UNITED STATES
NUCLEAR REGULATORY COMMISSION
WASHINGTON, D.C. 20555

SAFETY EVALUATION BY THE OFFICE OF NUCLEAR MATERIAL SAFETY AND SAFEGUARDS
RELATED TO THE ORDER APPROVING THE DECOMMISSIONING PLAN AND
AUTHORIZING FACILITY DECOMMISSIONING
LONG ISLAND POWER AUTHORITY (LIPA)
SHOREHAM NUCLEAR POWER STATION, UNIT 1
DOCKET NO. 50-322

Figure 1

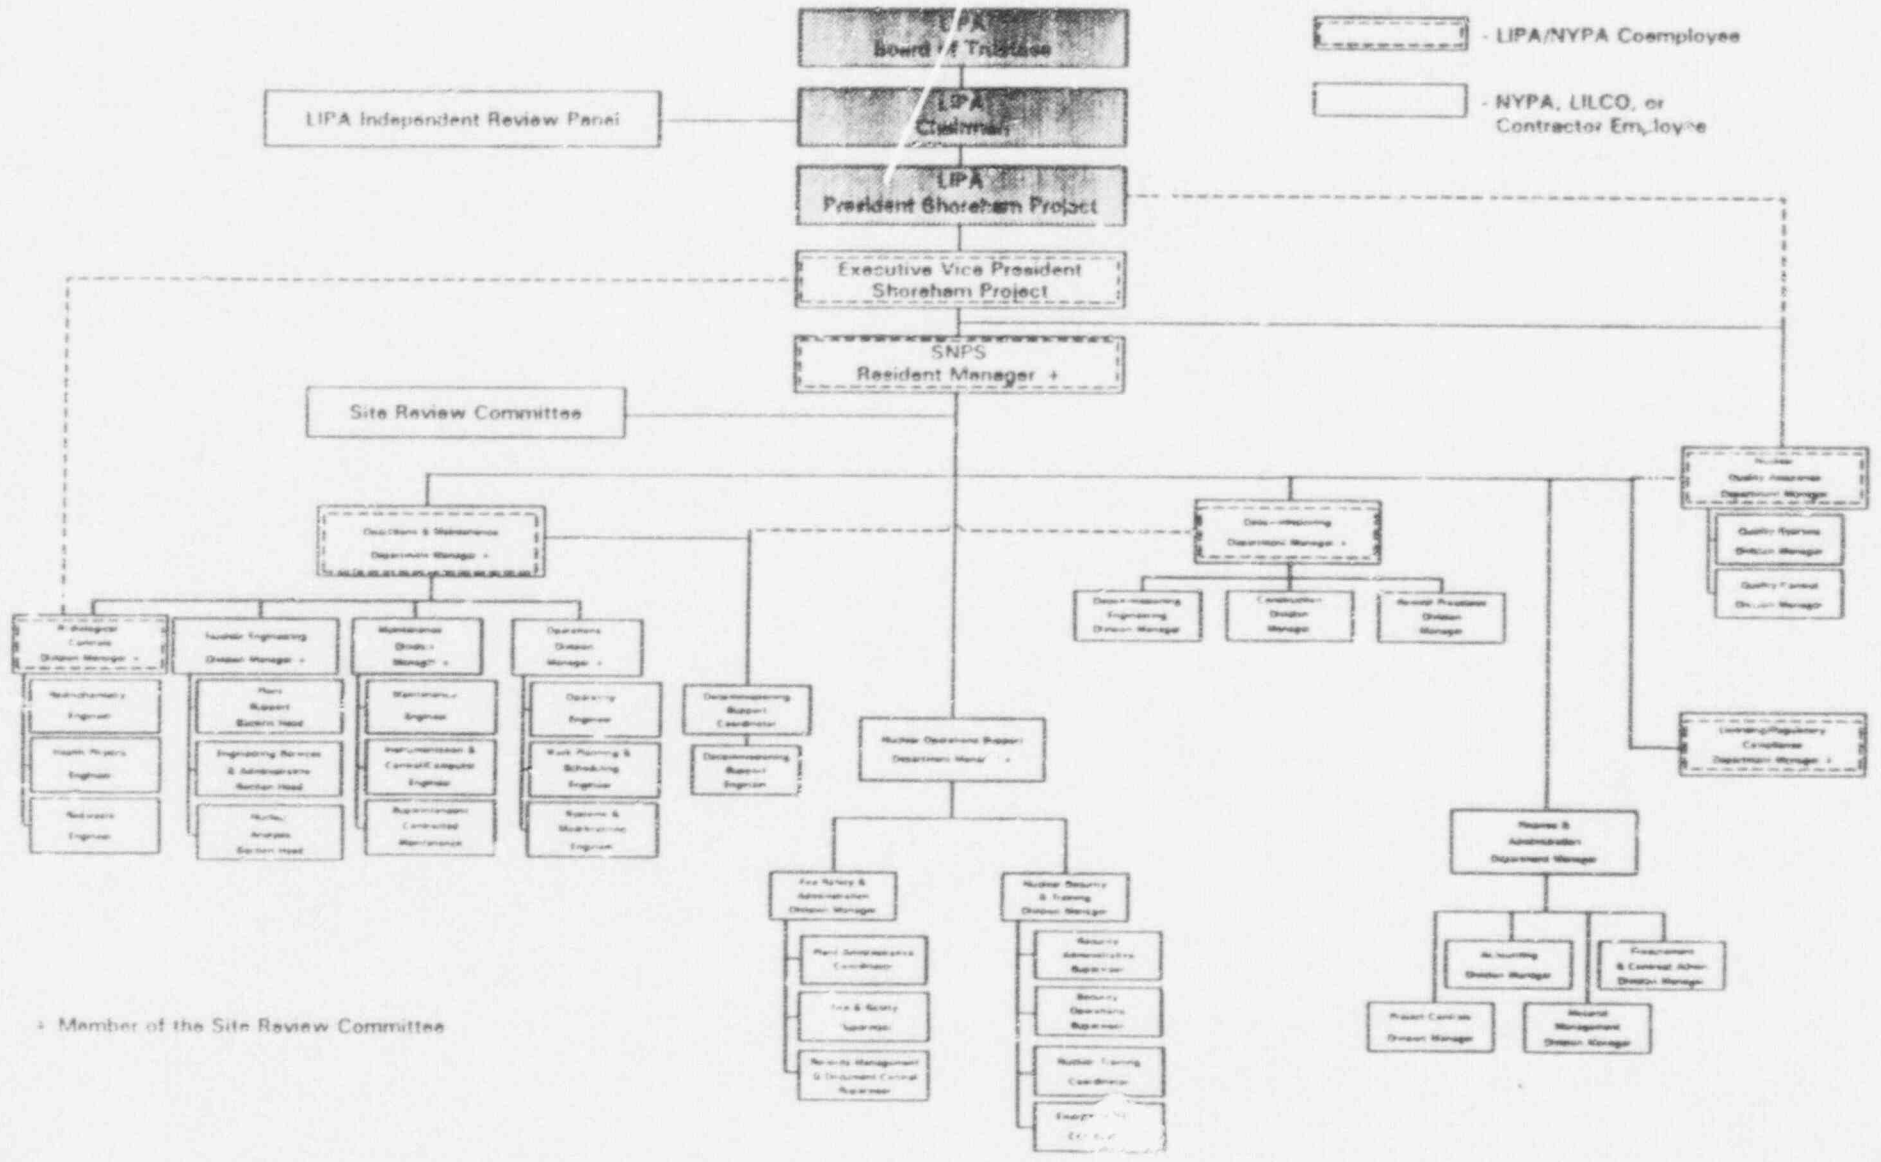
The licensee's overall organization is described in Section 4.8 of the EA (Ref. 6) and shown here in Figure 1. The positions that are considered to be the most vital to the conduct of safe decommissioning activities are filled by seven "coemployees," of the New York Power Authority (NYPA), who have nuclear experience gained while working by NYPA. The authority for the co-employment arrangement is derived from a binding agreement between LIPA and NYPA.

The overall control and responsibility onsite for the decommissioning rest with the Resident Manager who is a "coemployee." Five major functions report directly to the Resident Manager: 1) Decommissioning Project Manager, 2) Operations and Maintenance Department Manager, 3) Licensing/Regulatory Compliance Manager, 4) Nuclear Quality Assurance Department Manager, and 5) Radiological Controls Division Manager.

The Radiological Controls Division Manager reports directly to the Operations and Maintenance Manager, but also has direct access to the Executive Vice President - Shoreham Project, if radiological health and safety matters are not satisfactorily addressed through the normal reporting chain.

The licensee's organization provides a clear and logical breakdown of functional responsibilities, and a clear chain of command. The licensee's documentation includes qualification statements (resumes) for the persons designated as "coemployees," that is, Operations and Maintenance Department Manager, Radiological Controls Division Manager, Nuclear Quality Assurance Department Manager, and Decommissioning Project Manager.

The staff's evaluation of the licensee's Decommissioning Organization finds that the licensee's corporate and project organizations are acceptable based on the provisions of NUREG-0800, "Standard Review Plans for the Review of Safety Analysis Reports for Nuclear Power Plants" (Ref. 13), Section 13.1.1 "Management and Technical Support Organization," and Sections 13.1.2 and 13.1.3, "Operating Organization."
